PRESERVING AUSTRALIA'S OLDEST GARDEN SUBURB

DRAFT DEVELOPMENT CONTROL PLAN NO. 27 HUNTER'S HILL VILLAGE

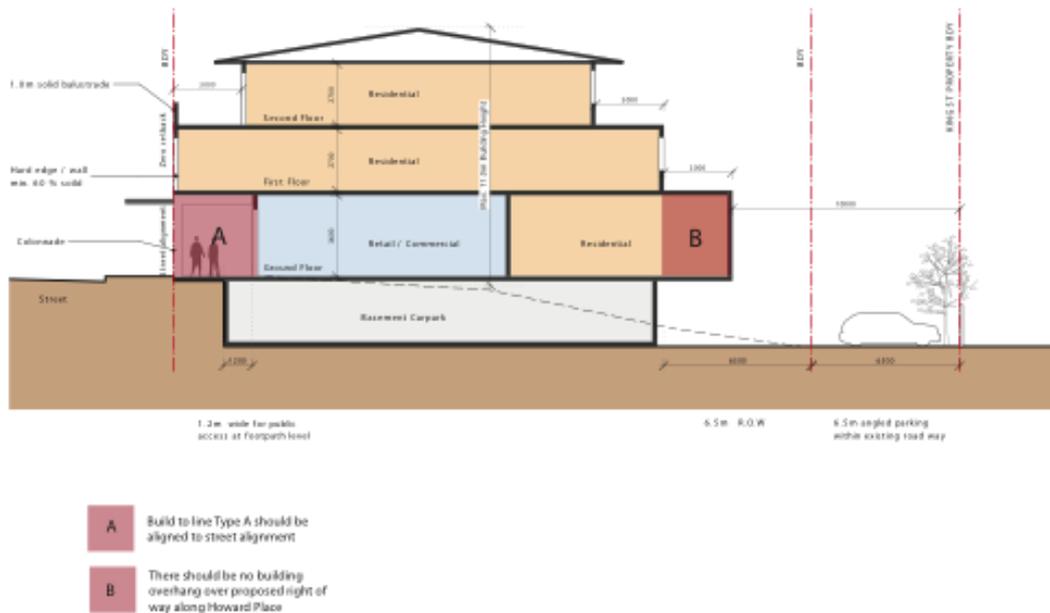
3. The Trust would urge that the consistent use, throughout the DCP, of the word “present” with reference to the number of storeys cited, be deleted. To “present”, for example, a two storey façade to the street, inevitably assumes from a development potential that a third storey is permissible. (See page 2-5, 3rd paragraph; page 3-2, objective vii; and others.)
